Number 969

Date: 12/21/2020
To: Affected Graco AFTD Distributors
Subject: F340e and F800e Feed Issues

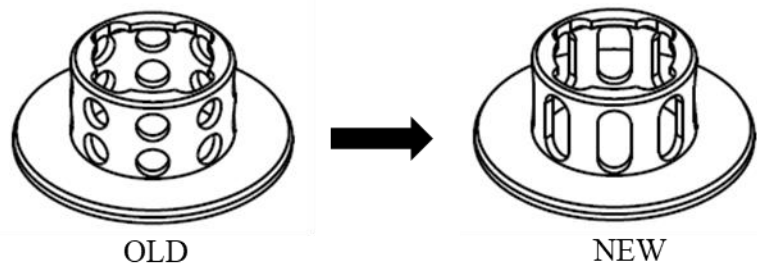
It has come to our attention that occasional material feed issues have been encountered in the field. Two updates were made – these changes have been field tested and eliminated any feed issues that had been occurring.

Two updates were implemented to resolve this issue. The piston rod was updated to increase piston check ball travel (bottom left image), and the inlet ball guide was updated from a series of holes to slots (bottom right image).

To replace your F800e or F340e piston rod and inlet ball guide, order the parts listed for each system in the table below. For proper repair procedures see instruction manuals 3A5653 (F800e) and 3A6393 (F340e).
